TEXAS COMMISSION ON ENVIRONMENTAL QUALITY

Re: Edwards Aquifer, Comal County

Name of Project: **Setterfeld Estates**; Located along the east right-of-way of FM 3351 north of Cibolo Creek; Fair Oaks Ranch, Texas

Type of Plan: Request for Approval of a **Water Pollution Abatement Plan (WPAP)**; 30 Texas Administrative Code (TAC) Chapter 213 Edwards Aquifer

**SANITARY SEWER FORCE MAIN
PLAN and PROFILE**
(STA. 10+00 to STA. 20+00)

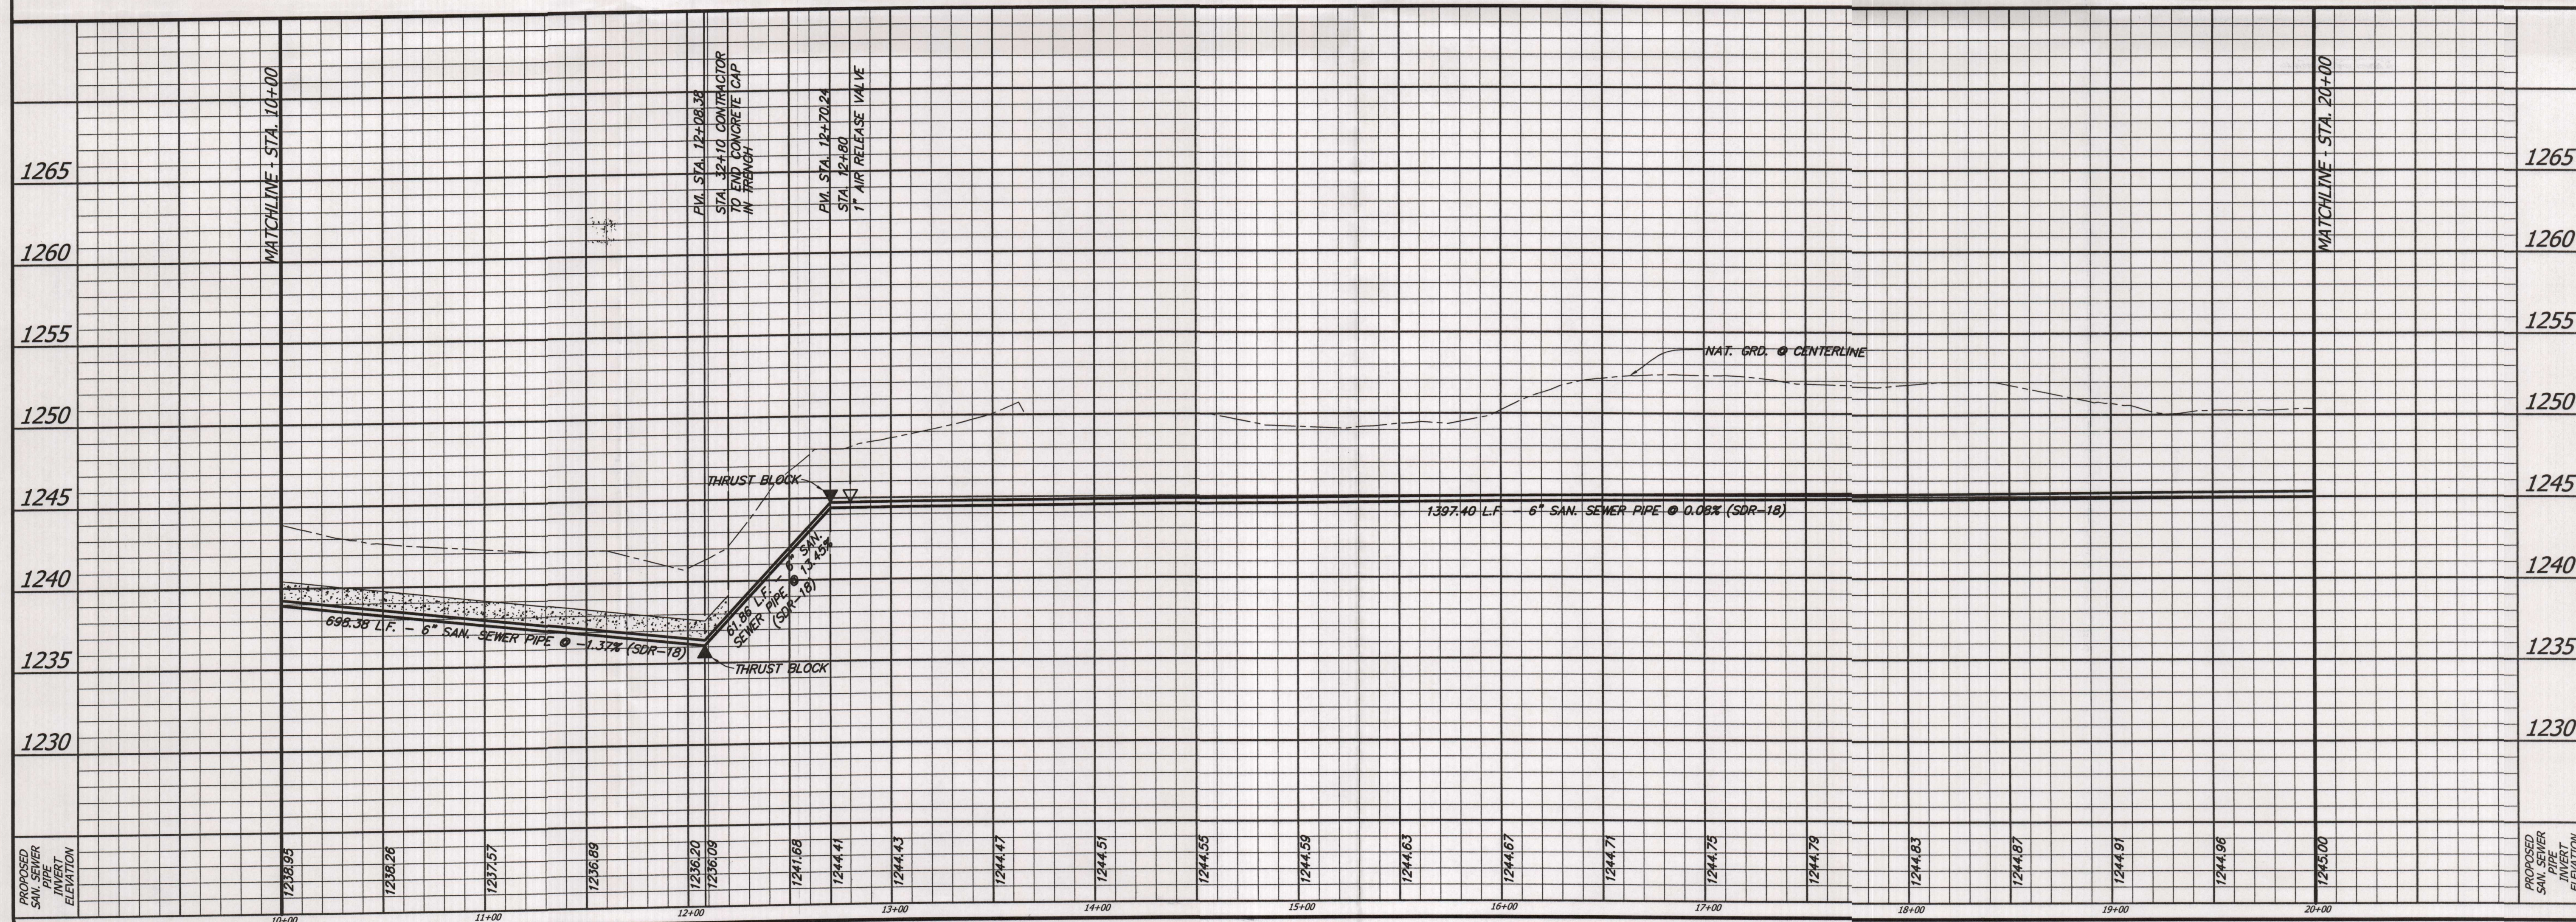
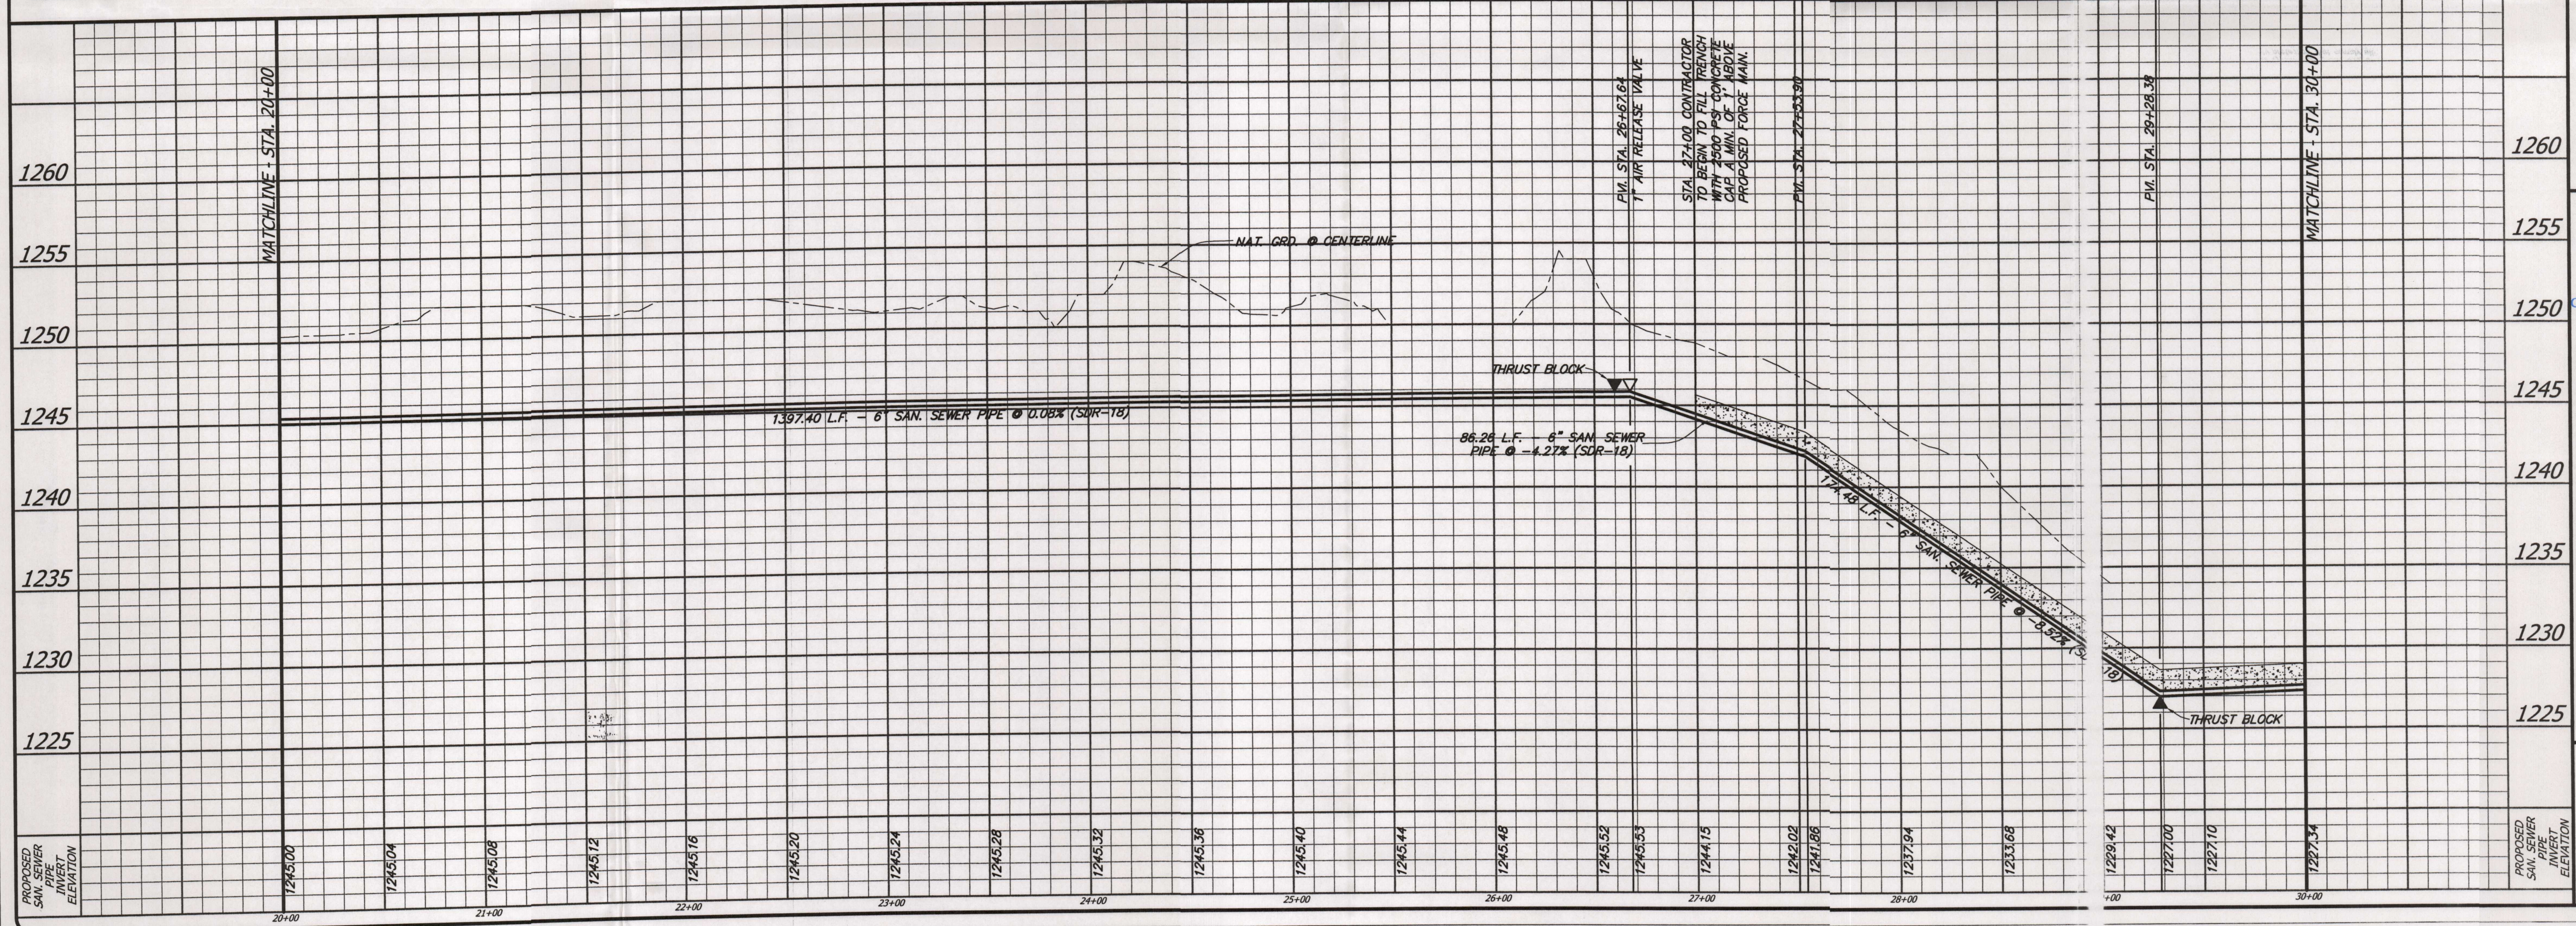
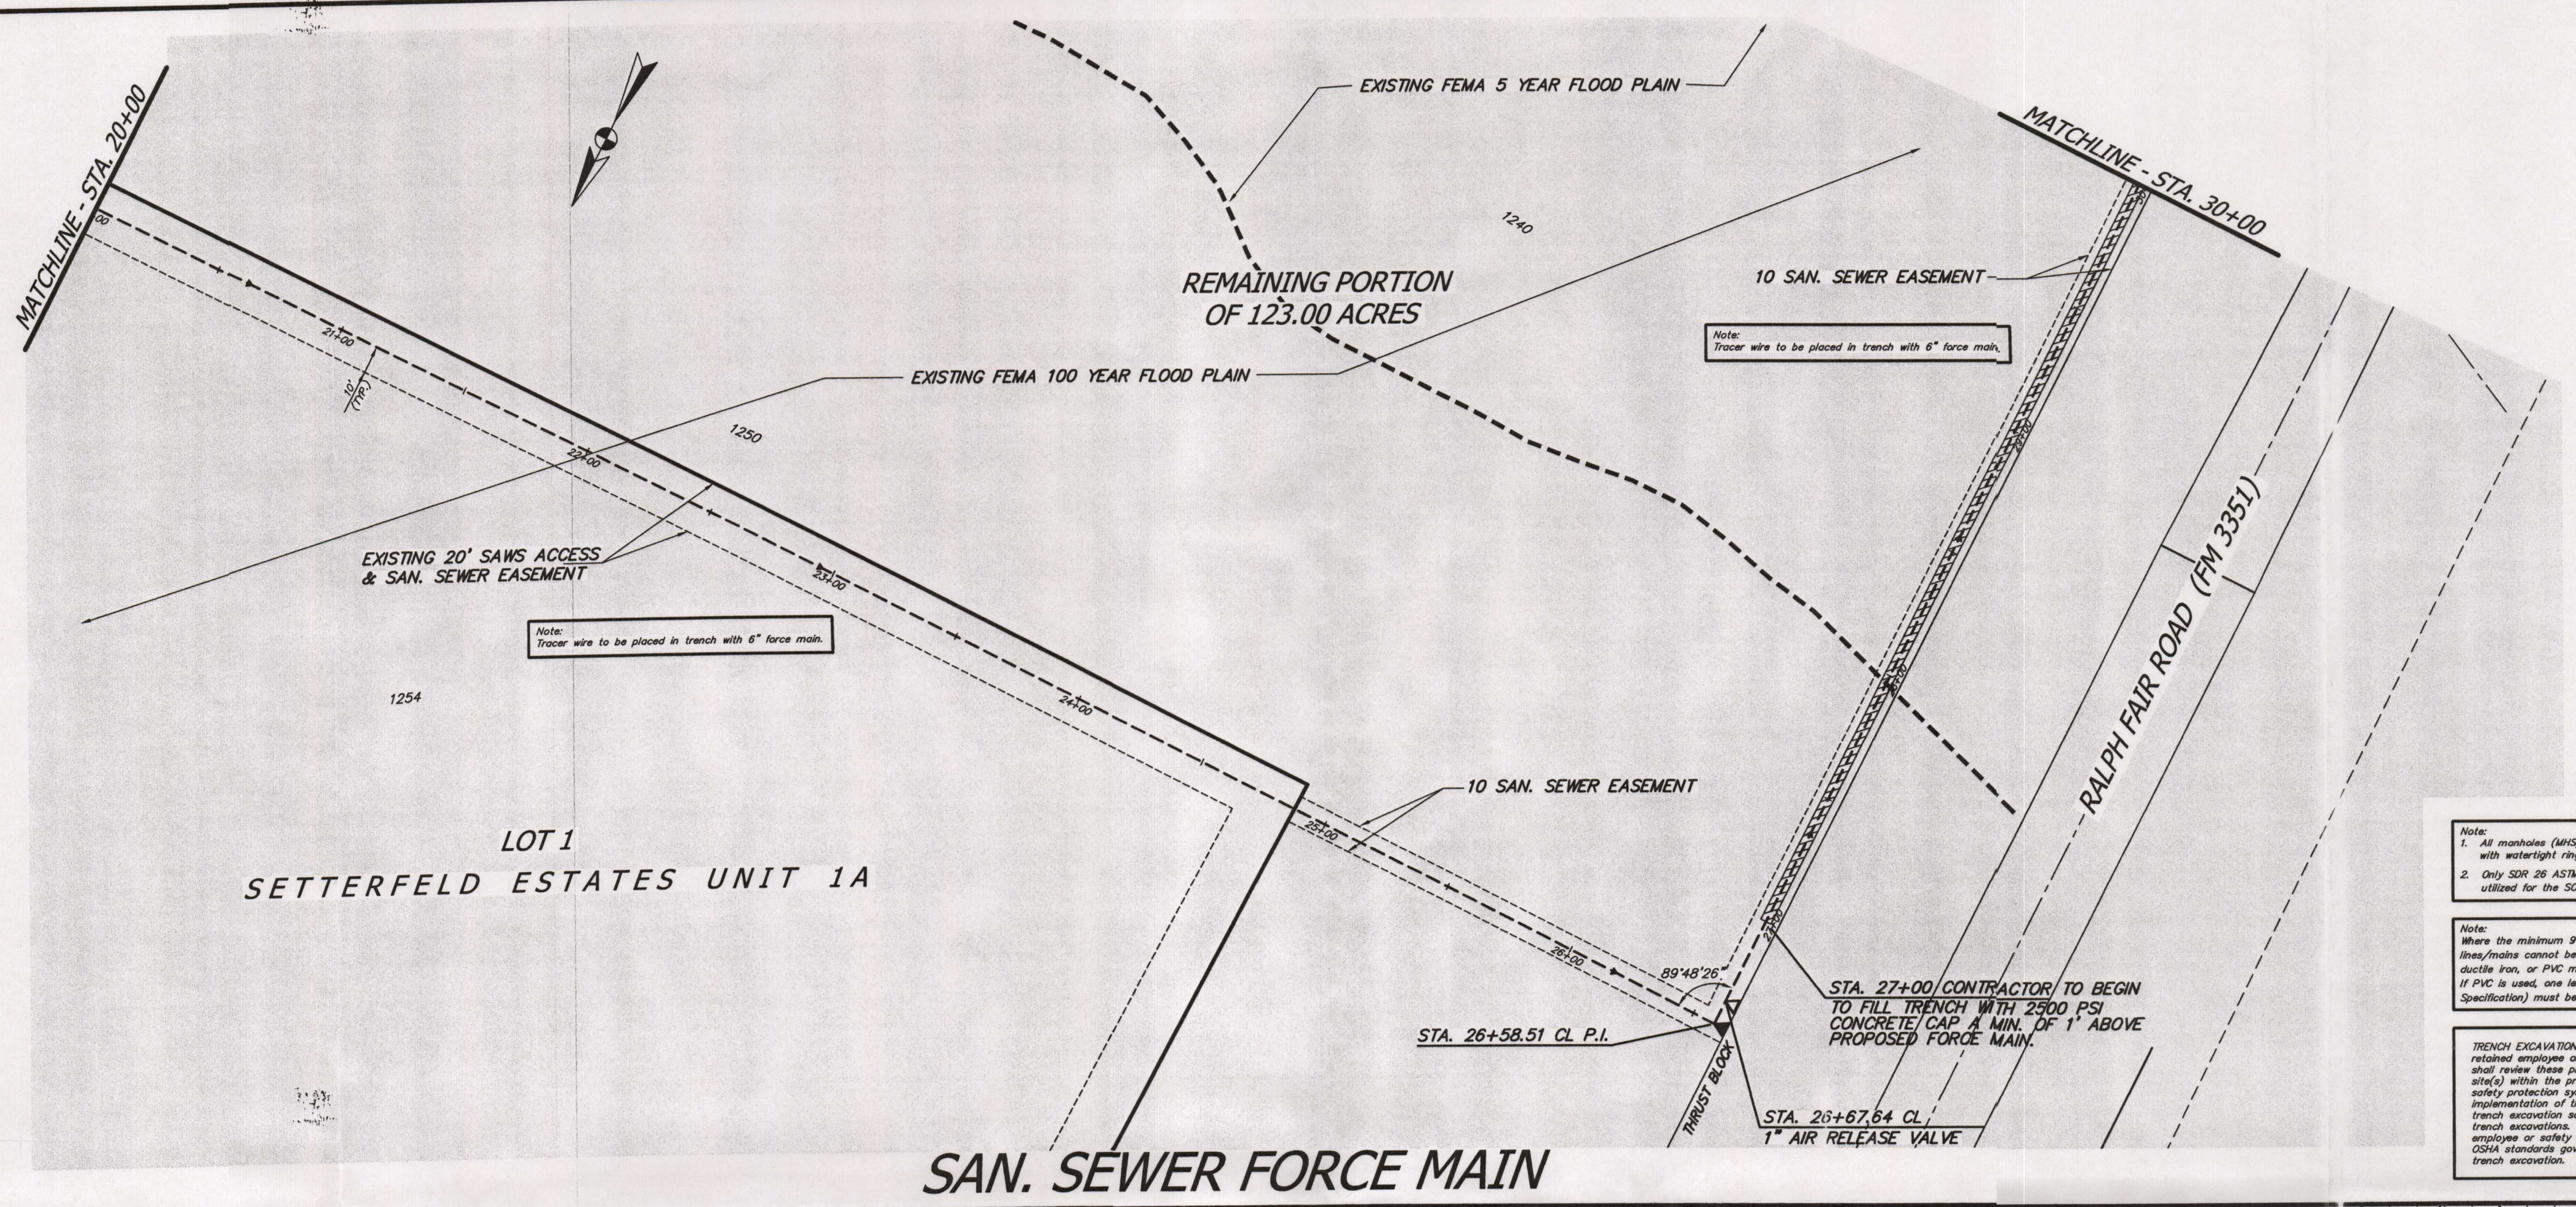
As per your fax of December 8, 2011 and our meeting on December 9, 2011, I have revised the force main calculations and the lift station pump design.

To assure 3fps of flow in the force main, the lift station pumps were revised to 275 gpm pumps. A "Duty Analysis" curve was produced for the force main vs. pump performance. This confirmed the pump selection.

Next the force main was analyzed for head loss at the design flow, including friction loss for fittings. The "Unibell Pipe Manual" was utilized to check the pipe design for Pressure Rating, Short Term design, and Cyclic Stress. Previous calculations used the pipe rating pressure of 150 psi as the operating pressure. The calculations have been revised using the operating pressure of 16 psi and the maximum pressure of 23 psi.

The AWWA Manual M23, Second Edition and the pipe rated pressure of 150 psi was utilized for thrust block calculation. The construction plans were updated to indicate the selected pump design, the addition of one air release valve at Station 12 + 80 and the thrust block sizing noted above.

- ▲ THRUST BLOCK
- 45° BENDS - 1.5' x 3' = 4.5 S.F.
- 90° BENDS - 2.1' x 4' = 8.4 S.F.
